**PRELIMINARY
SITE PLAN**

FRANCE AVE S AND MINNESOTA DR

Minnesota Center INSPIRATION STUDY

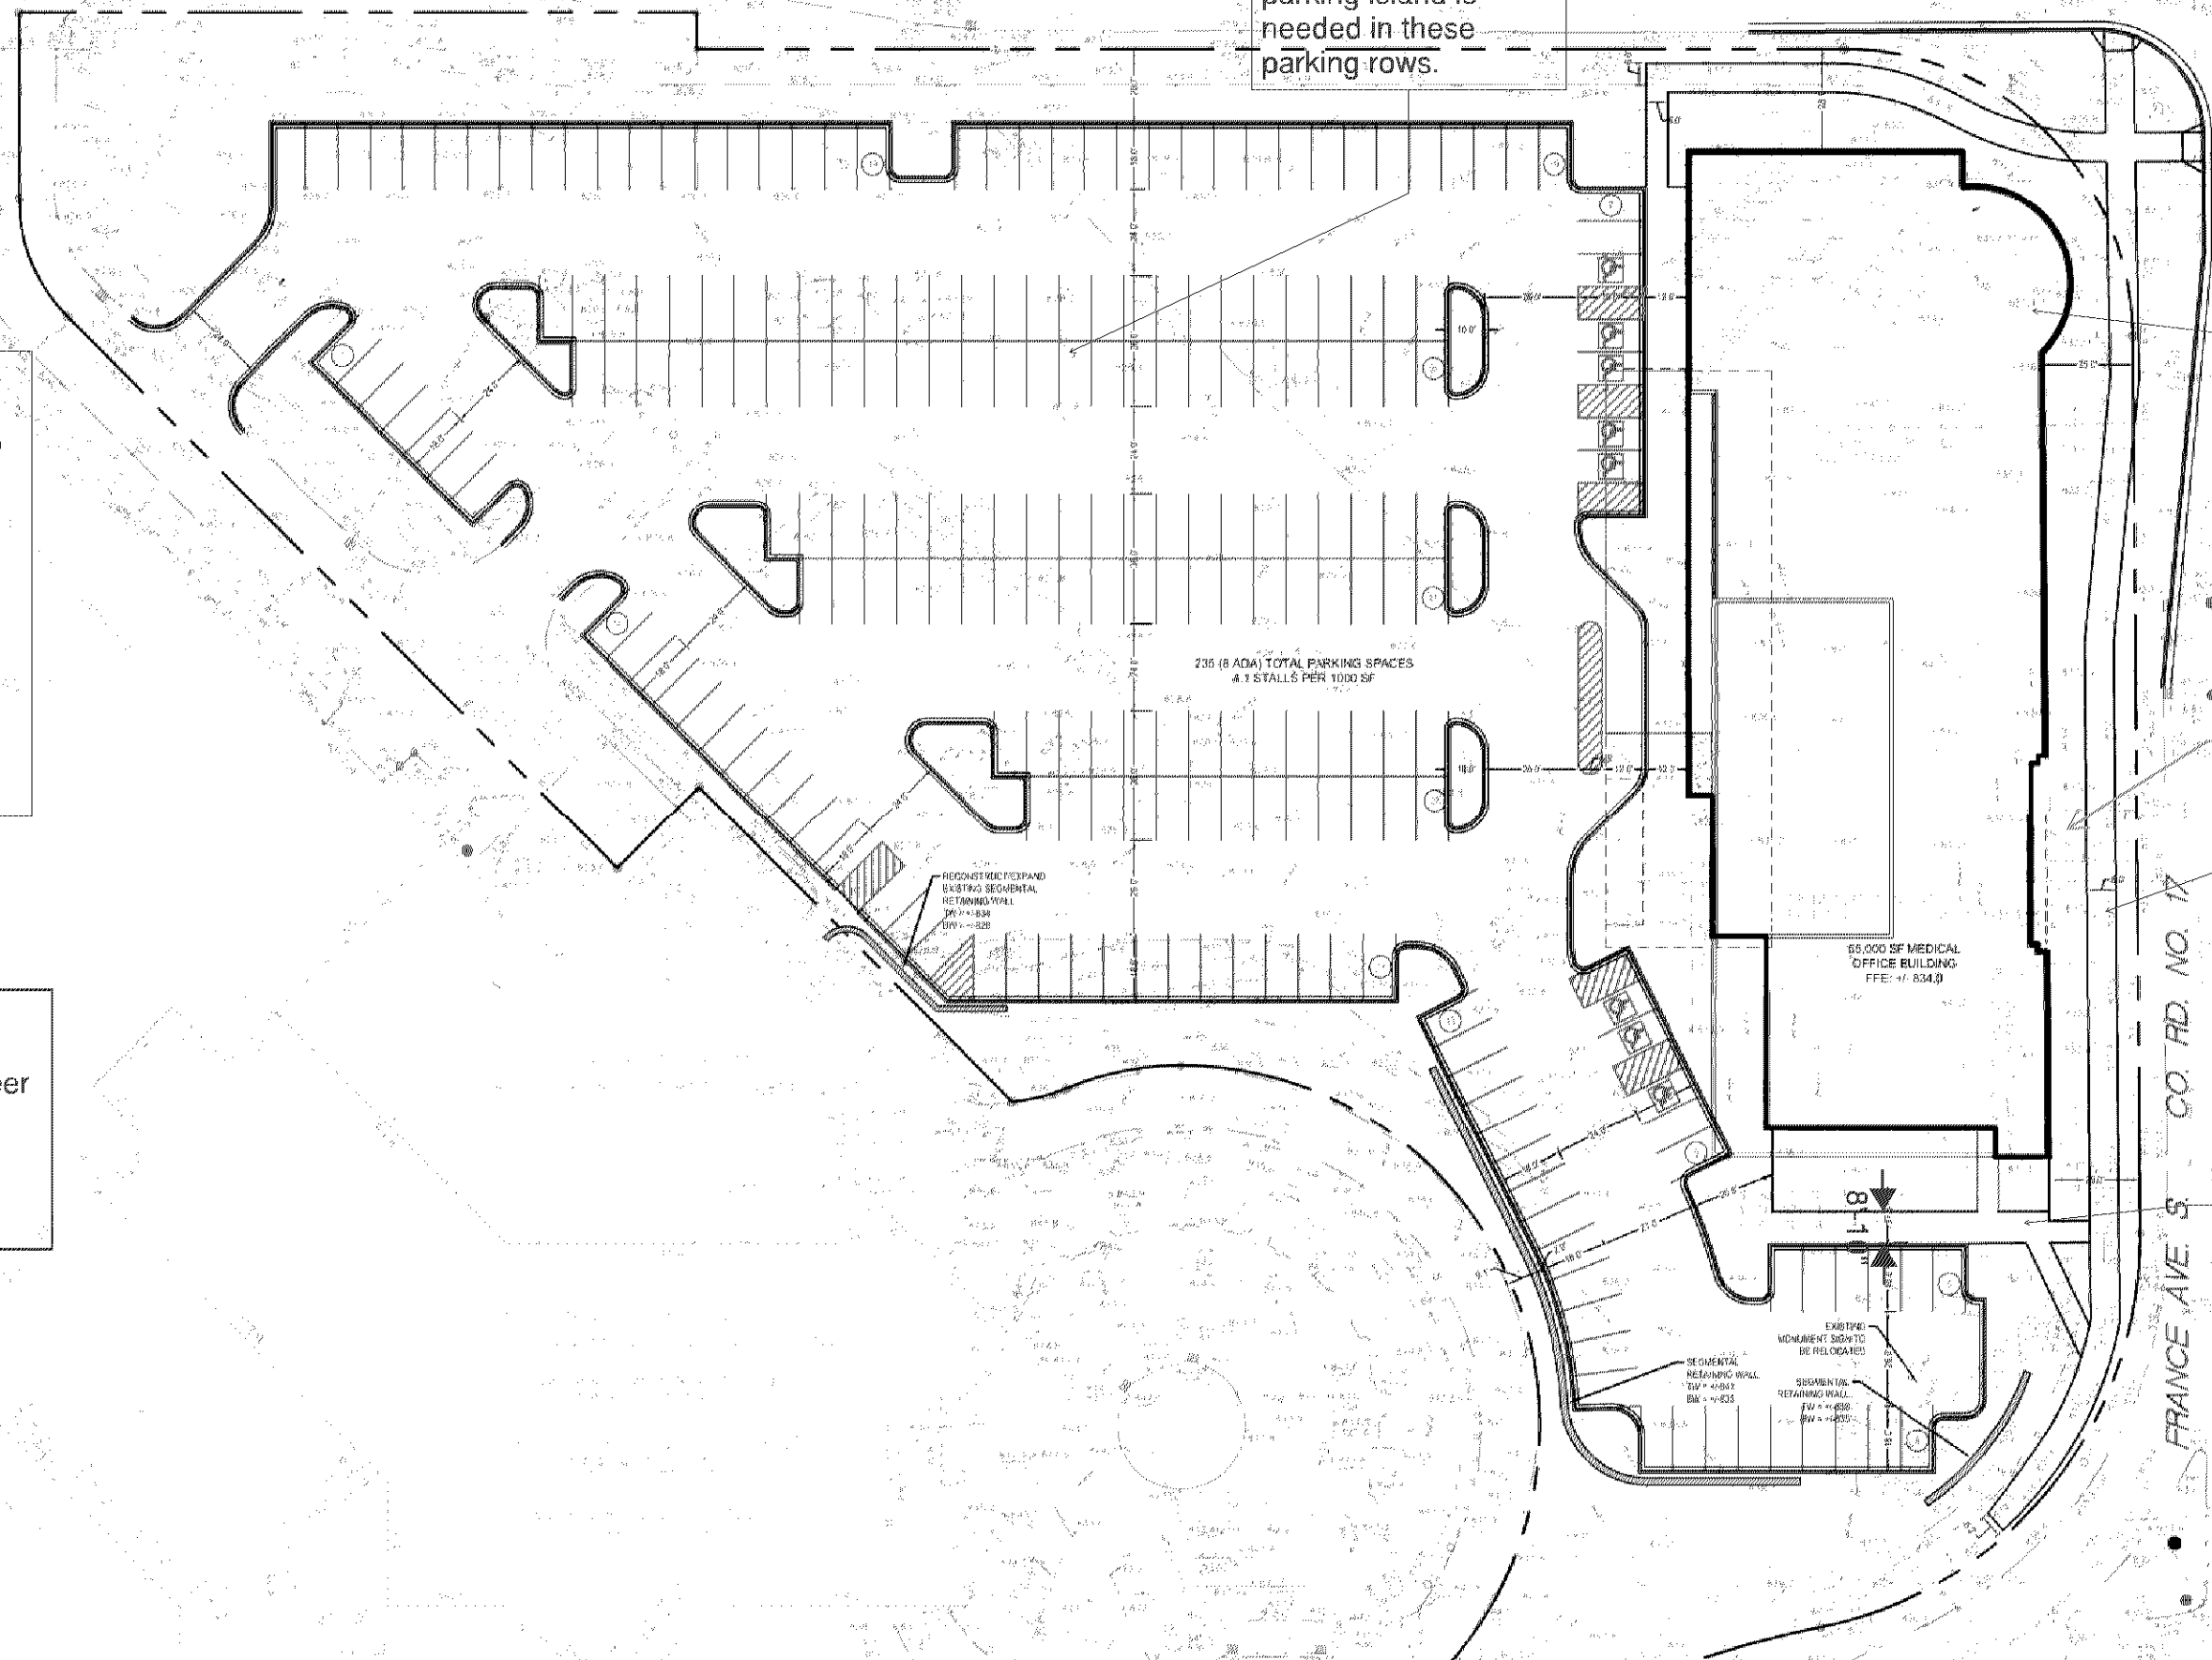
An intermediate parking island is needed in these parking rows.

Is a parking structure expansion proposed at MN Center? If so, this will need to be depicted as part of a preliminary development plan that includes future improvements.

If future improvements are depicted on the MN Center property, that property owner must consent to the development application.

Methane mitigation may be required if Geotechnical Engineer requires it. Provide soils report upon Building permit application.

Is some sort of patio or outdoor amenity space intended for the France/Minnesota corner? Staff believes some active space would benefit the project overall.

Possible vacation of the transportation facility easement.

8-foot sidewalk along France Avenue meets the City requirement.

Ensure vehicle overhang is accounted for where parking spaces abut sidewalks. Generally, this means a minimum 7-foot sidewalk

With a proposed 0.33 FAR, the Preliminary Development Plan (PDP) should demonstrate how additional development could be accommodated on the site. This could take the form of a third level or a separate freestanding building, whichever could more reasonably be accomplished.
